# SERVICE BULLETIN

No. 604A

Piper Aircraft Corporation

PART I: Forward Baggage Door Locking System Modification

FIGURE 1

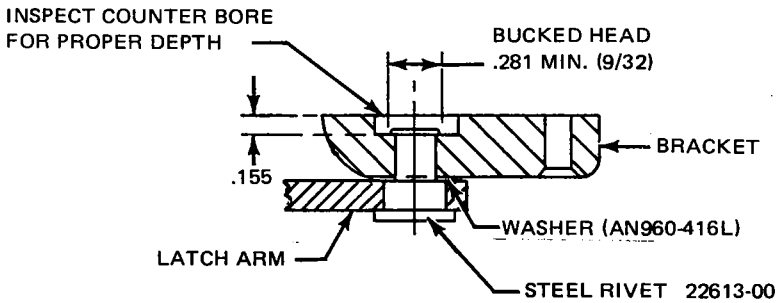
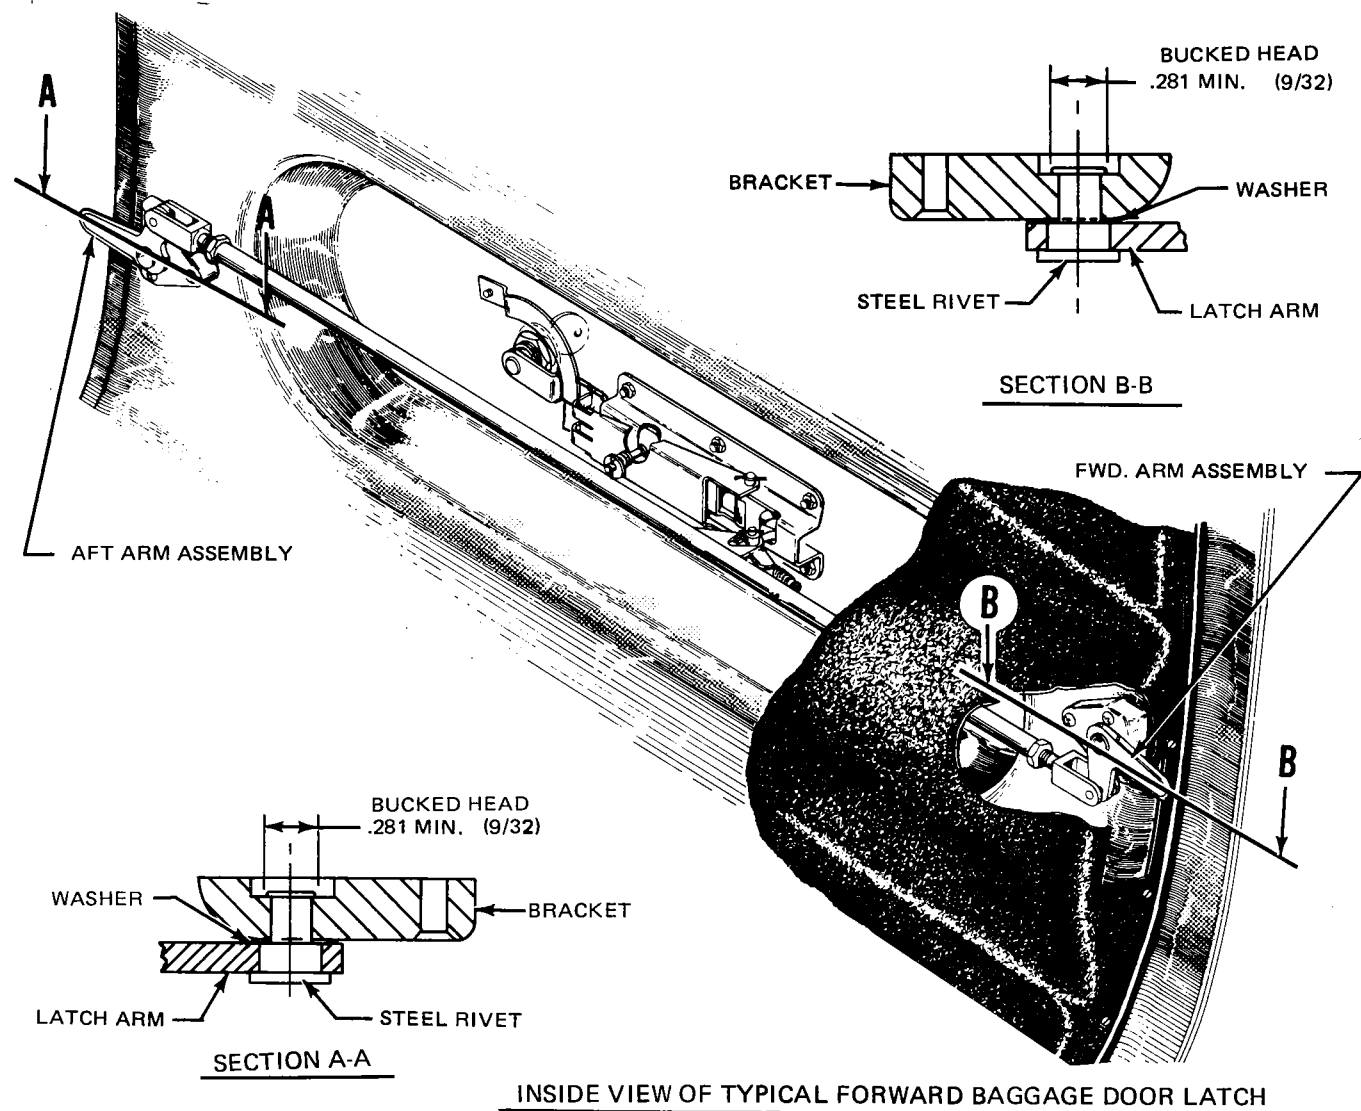
The door lock arm assemblies on the forward or nose, baggage door on the above referenced models are secured to brackets by steel rivets. It has been determined that for optimum arm assembly-to-bracket security, the bucked (peened) head of the rivet should have a diameter of .281 inch or greater.

1. Refer to Section IV in the appropriate Service Manual and remove the door latch arm assemblies from the forward baggage door.
2. With the latch arm assemblies removed from the door, inspect as follows.
  - a. Measure the diameter of the bucked head of the steel rivet that secures the latch arm to the bracket (Refer to Section A-A and B-B on Sketch A). This diameter must be .281 (9/32) or greater.
3. Latch arm assemblies with a bucked head diameter of .281 (9/32) or greater may be considered acceptable.
4. Latch arm assemblies with a bucked head diameter of less than .281 (9/32), must either be replaced with a new part as listed in the table below or may be reworked as follows.
  - a. Peen rivet head, in an acceptable manner, to achieve a bucked head diameter of .281 (9/32) or greater, as shown.

NOTE: Latch arm assemblies not retaining freedom of rotational movement, after head of rivet is peened, must be replaced with a new part as listed in Table below or steel rivet may be replaced as follows. (Refer to Sketch "A", Figure 1. )

- (1) Carefully drill out steel rivet. Maximum allowable hole size after drilling is .267.
  - (2) Inspect the .50 diameter counter bore in bracket to determine if counter bore is the proper depth as shown. Counter bore the hole to .155 if it is not the proper depth.
  - (3) Install new rivet Part No. 22613-00 and peen in an acceptable manner to achieve a bucked head diameter of .281 (9/32) or larger.
